UNITED STATES PATENT AND TRADEMARK OFFICE

APPLICATION NO.	FILING DATE	FIRST NAMED INVENTOR	ATTORNEY DOCKET NO.	CONFIRMATION NO.
10/039,805	10/19/2001	Henry Colombo	CSA-101-B	9375

Office Action Summary

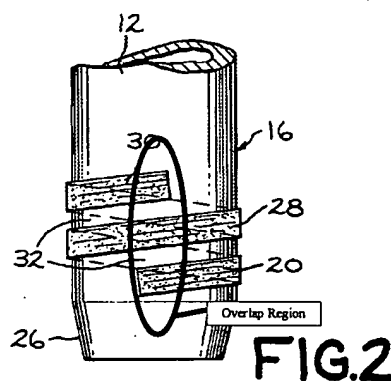
Reesor does not disclose a double-sided tape applied only around the exterior surfaces of the pair of the pipe ends, wherein the double-sided tape has a first end and a second end and the second end forms and overlap of the first end around the pair of the pipe ends. Kushner et al teaches a double-sided tape (28) applied only around the exterior surface a pipe end (16), wherein the double-sided tape has a first end and a second end and the second end forms and overlap (see Figure 2 below) of the first end

around the pipe end, so as to have "a greater resistance to sheer force than the usual adhesive customarily used in joints that is applied in a liquid state" (col. 2, lines 29-33). As Kushner et al relates to a joint for adhesively connecting tube members, it would have been obvious to one having ordinary skill in the art at the time the invention was made to provide a double-sided tape applied only around the exterior surface a pipe end, wherein the double-sided tape has a first end and a second end and the second end forms and overlap of the first end around the pipe end, so as to have a greater resistance to sheer force than the usual adhesive customarily used in joints that is applied in a liquid state, as taught by Kusher et al.
